M1985-184 - Bivens Pit- TR-2: 2nd Submission and Comments to Adequacy Review

**Subject: Bivens Trucking and Excavating, Inc –
Bivens Pit, Permit No. M-1985184
Response to Adequacy Review on Technical Revision 2**

Telesto Solutions, Inc. (Telesto) submits this letter on behalf of Bivens Trucking and Excavating, Inc. (Bivens) to address comments and questions in Adequacy Review No. 1 (AR-01) dated January 8, 2021. We appreciate your time in this matter. This letter repeats the comment/question from the adequacy review in *italics* with a response immediately following. Responses and questions that led to a change in Technical Revision 2 (TR-02).

FIGURE 5
PLAN 2 - POST MINING LAND USE & RECLAMATION
PLAN
862 W WILLOX LANE
FORT COLLINS, COLORADO

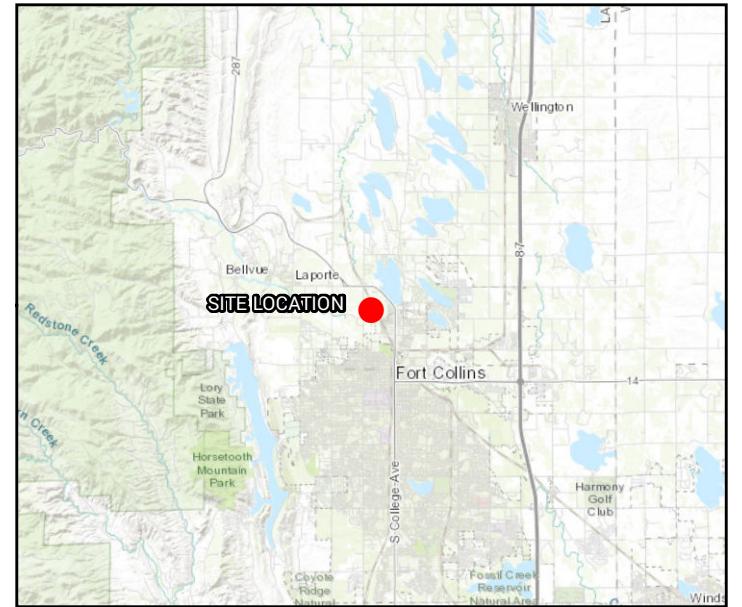
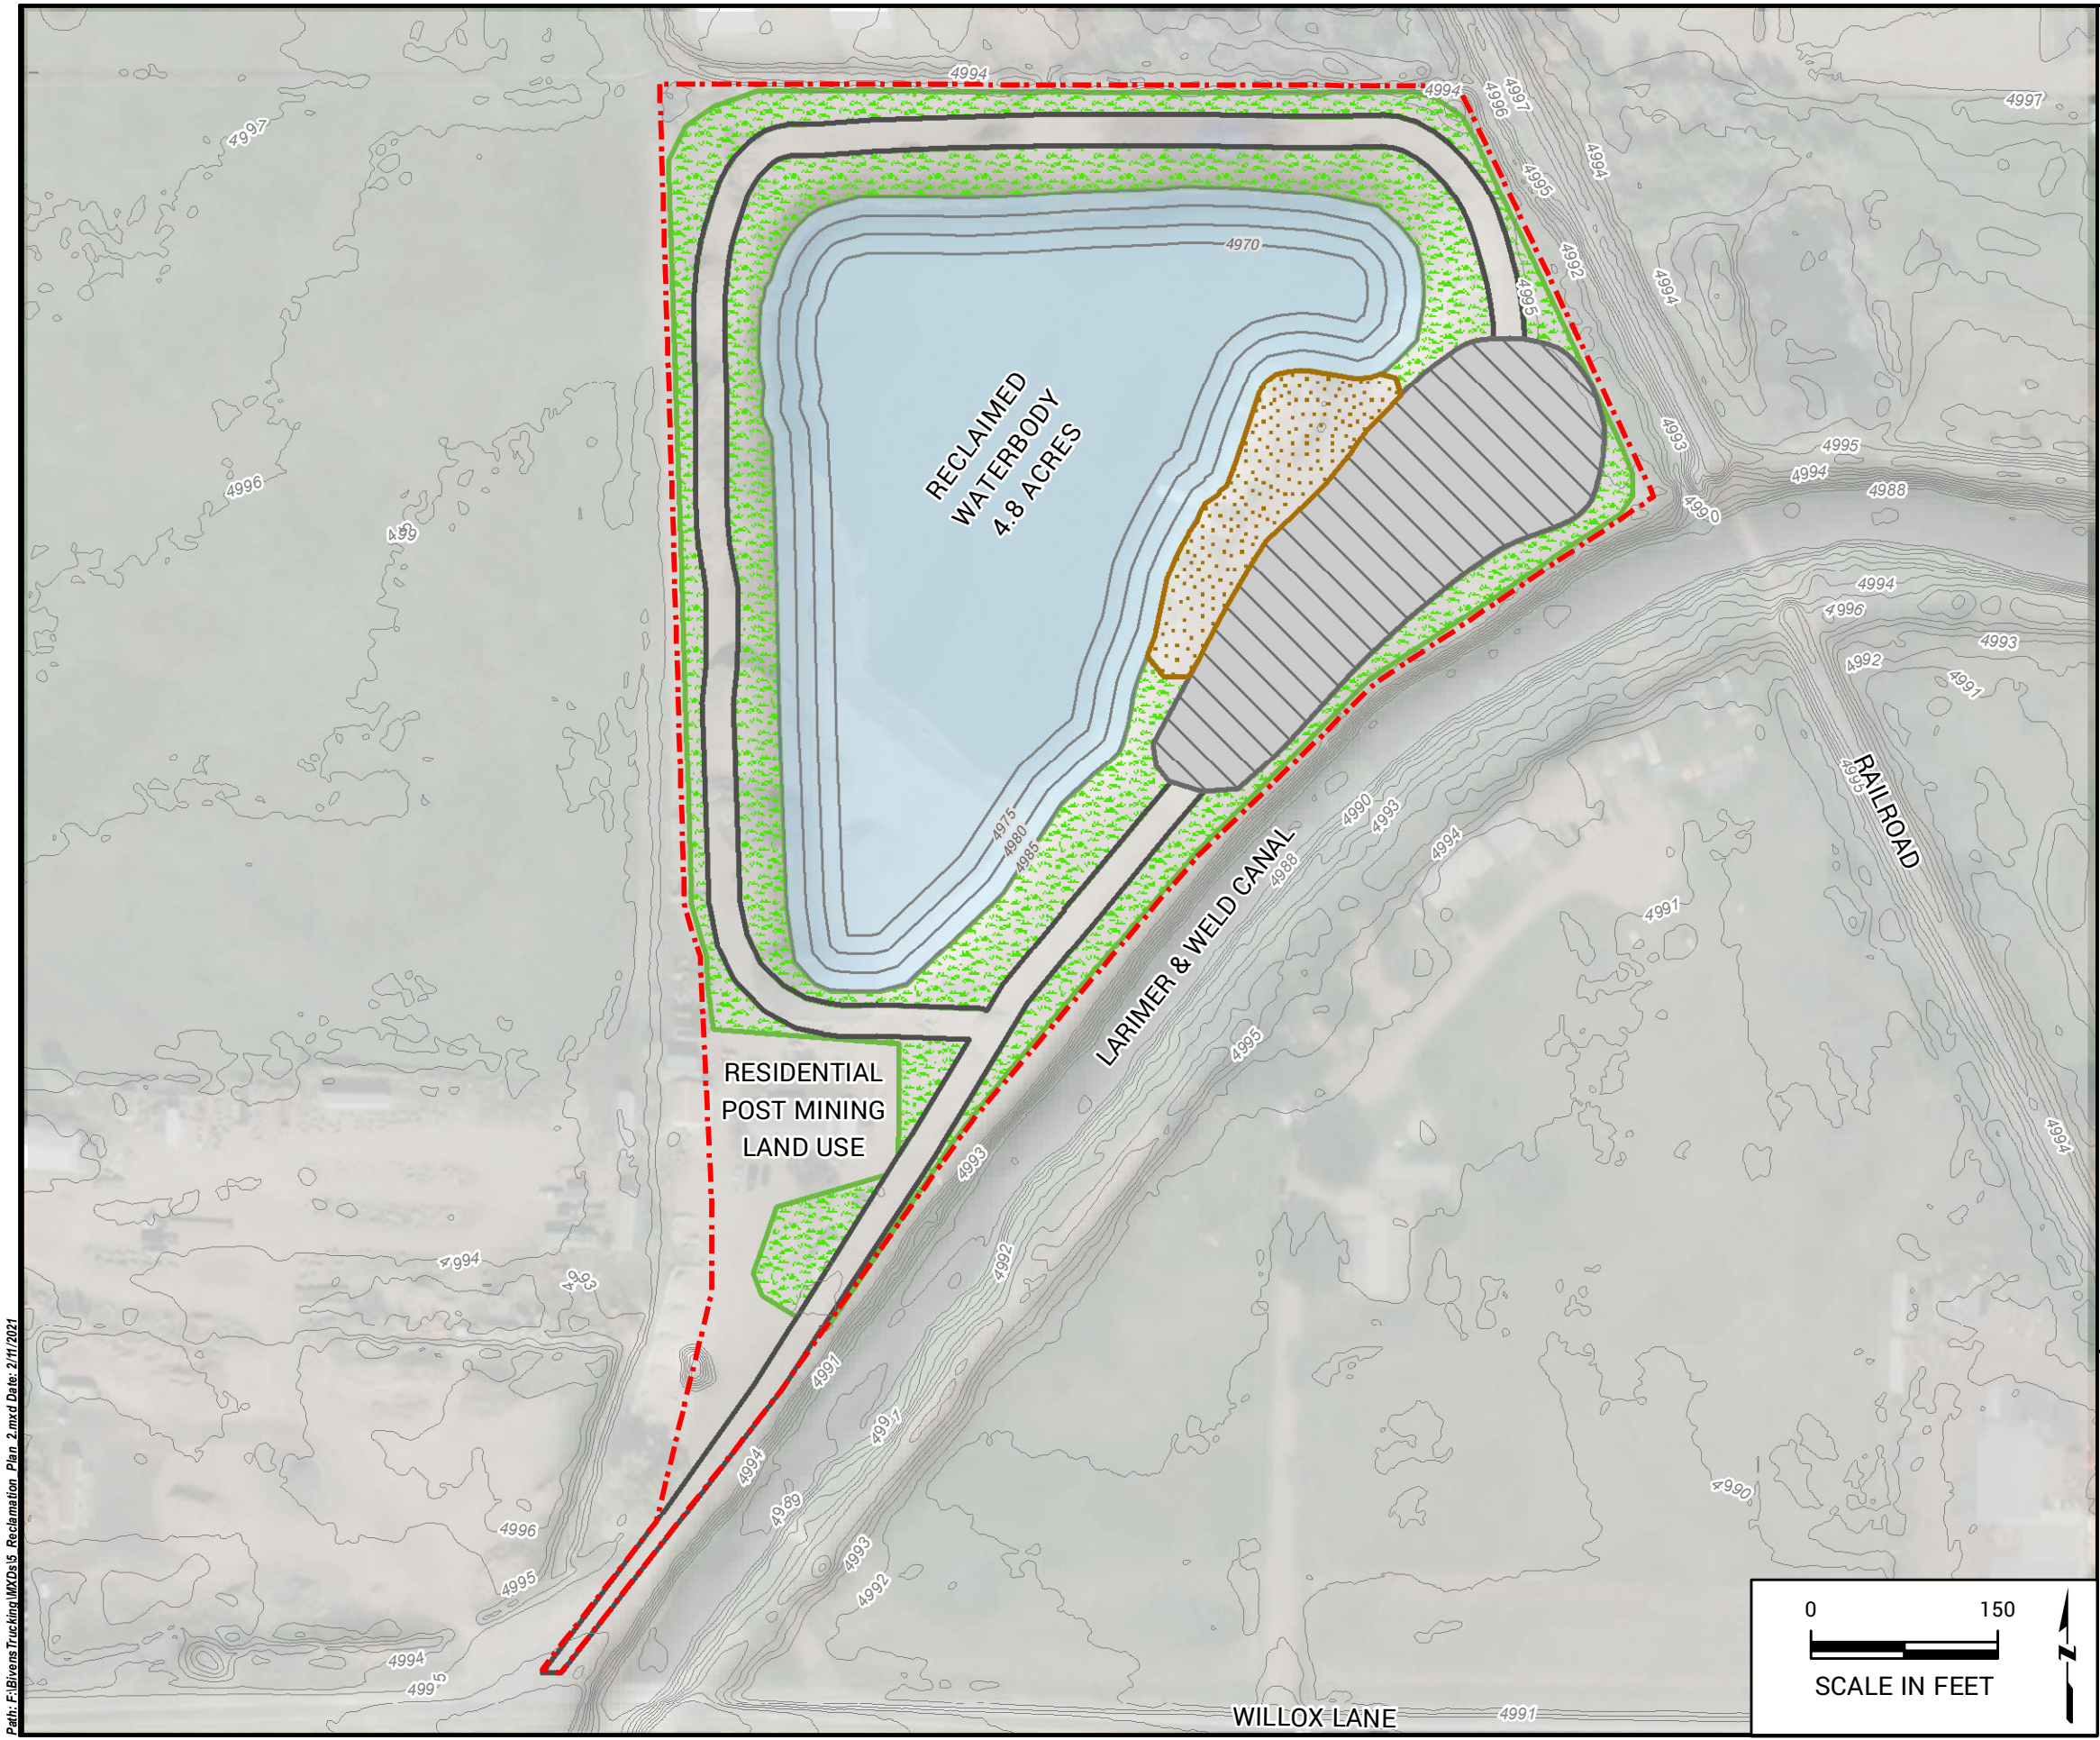
On Figure 4 – Post Mining Land Use and Reclamation Plan, features from both of the proposed reclamation plans are shown on this map, including the potential water feature and the potential pond backfill area (from the 2nd proposed reclamation plan). Please provide a separate reclamation plan map for each of the proposed reclamation plans showing how each portion of the affected lands will be reclaimed for each of the proposed plans, including the correct acreages. While the operator will have the option of choosing which reclamation plan to implement at the site (after TR-02 approval), the Division must calculate the required financial warranty based on the most costly reclamation plan proposed, in the event the permit was revoked and the State had to complete reclamation of the site. Alternatively, the operator could commit to one reclamation plan, and modify Figure 4 accordingly.

Bivens proposes two final reclamation plans, Plan 1 and Plan 2. Both final reclamation plans include additional figures made to match quantities provided in Item 5. Please refer to updated TR-02 for the details of the two reclamation plans.
